**Re: Nusenda Credit Union/ 2801 Juan Tabo NE**  
**Request for Certificate of Occupancy**  
**Transportation Development Final Inspection**  
Architect's Stamp dated 08-31-23 (H21-D020)  
Certification dated 07-08-25

**Re: Building permit no. BP-2023-11751: New Branch office for Nusenda Credit Union at 2801 Juan Tabo NE, Abq NM.**

**Re: Nusenda Credit Union**  
**2801 Juan Tabo Blvd. NE**  
**30-Day Temporary Certificate of Occupancy**  
**Transportation Development Final Inspection**  
Architect's Stamp dated 10-26-22 (H21-D020)  
Certification dated 09-12-24

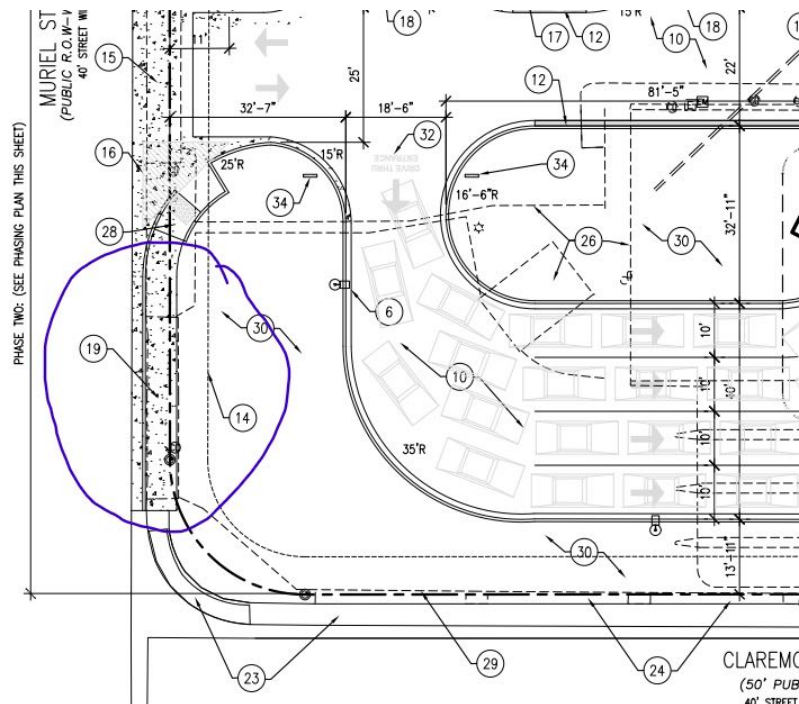
- Prior to issue a Perm CO, the construction of the site access off Muriel St. must be completed.

COMMENT ADDRESSED. SEE ATTACHED PHOTOS
